# SERVICE BULLETIN

No. 604A

Piper Aircraft Corporation

Subject:

SKETCH "A"

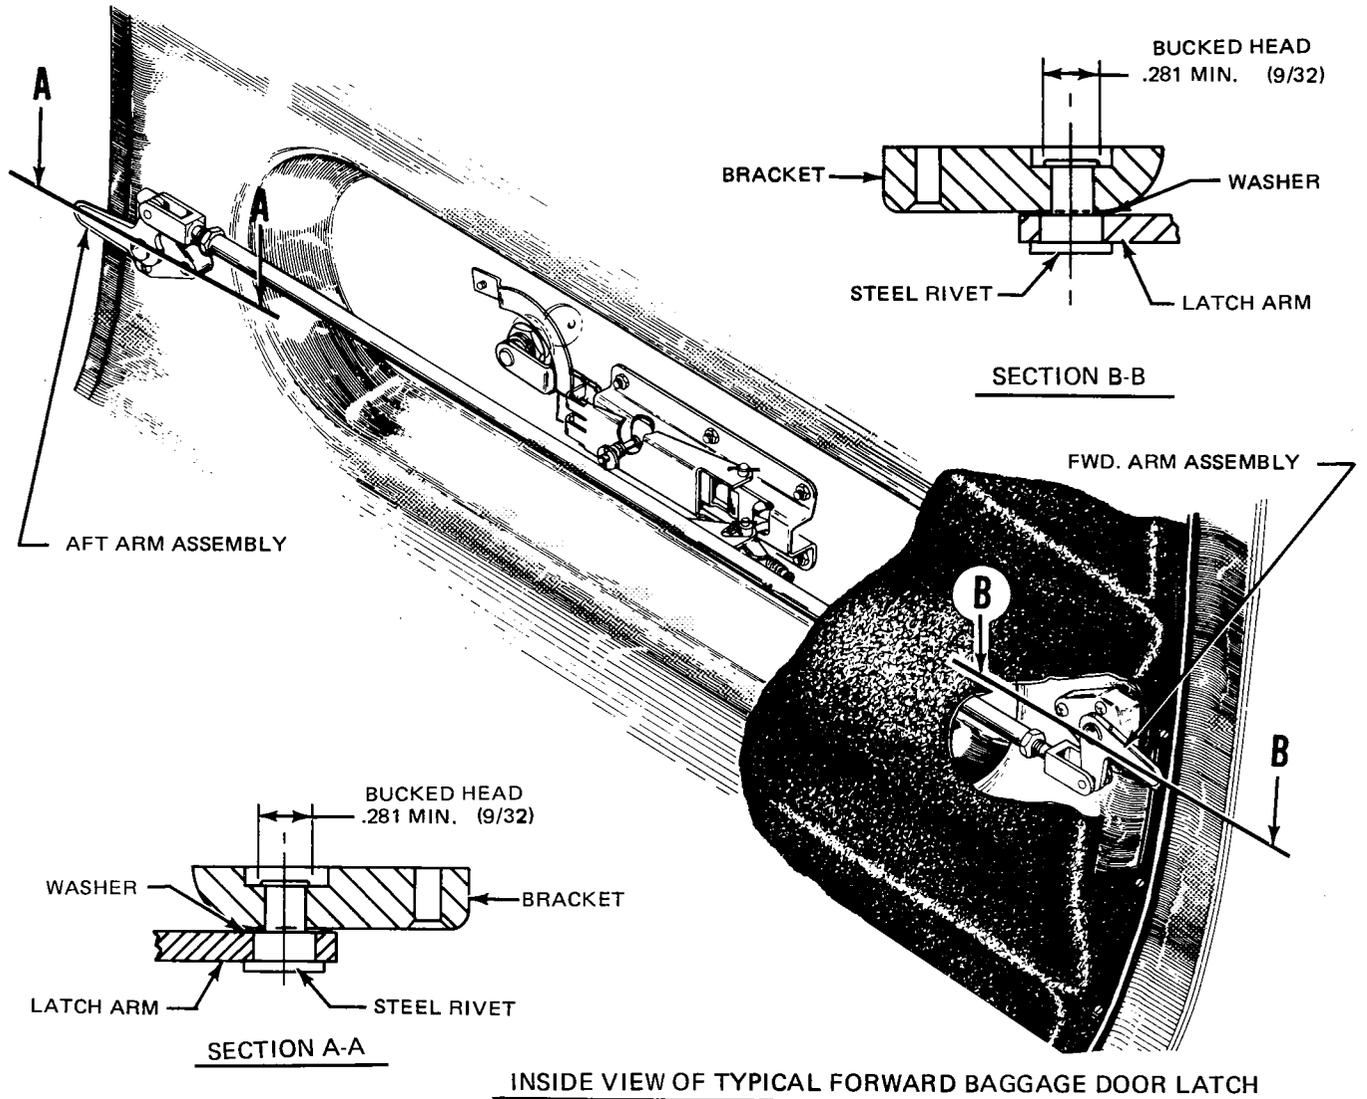
1. Refer to Section IV in the appropriate Service Manual and remove the door latch arm assemblies from the forward baggage door.
2. With the latch arm assemblies removed from the door, inspect as follows.
  - a. Measure the diameter of the bucked head of the steel rivet that secures the latch arm to the bracket (Refer to Section A-A and B-B on Sketch A). This diameter must be .281 (9/32) or greater.
3. Latch arm assemblies with a bucked head diameter of .281 (9/32) or greater may be considered acceptable.
4. Latch arm assemblies with a bucked head diameter of less than .281 (9/32), must either be replaced with a new part as listed in the table below or may be reworked as follows.
  - a. Peen rivet head, in an acceptable manner, to achieve a bucked head diameter of .281 (9/32) or greater, as shown.

NOTE: Latch arm assemblies not retaining freedom of rotational movement, after head of rivet is peened, must be replaced with a new part as listed in Table below or steel rivet may be replaced as follows. (Refer to Sketch "A", Figure 1.)

- (1) Carefully drill out steel rivet. Maximum allowable hole size after drilling is .267.
    - (2) Inspect the .50 diameter counter bore in bracket to determine if counter bore is the proper depth as shown. Counter bore the hole to .155 if it is not the proper depth.
    - (3) Install new rivet Part No. 22613-00 and peen in an acceptable manner to achieve a bucked head diameter of .281 (9/32) or larger.

NOTE: Latch arm assemblies not retaining freedom of rotational movement after rework, must be replaced with a new part as listed in Table below.
5. Install new or reworked latch arm assemblies to forward baggage door. Refer to Section IV in the appropriate Service Manual.
6. Make proper Logbook entry of Service Bulletin 604A "Part II" compliance.

FIGURE 1

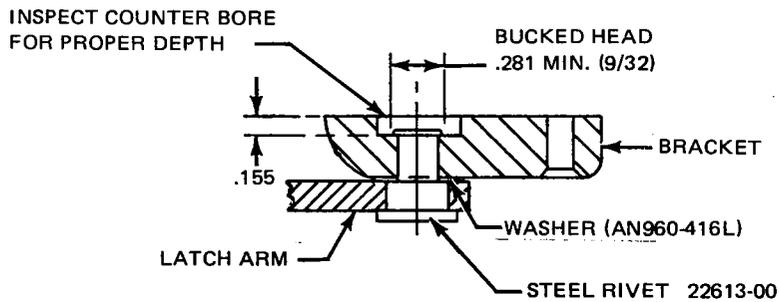
The door lock arm assemblies on the forward or nose, baggage door on the above referenced models are secured to brackets by steel rivets. It has been determined that for optimum arm assembly-to-bracket security, the bucked (peened) head of the rivet should have a diameter of .281 inch or greater.
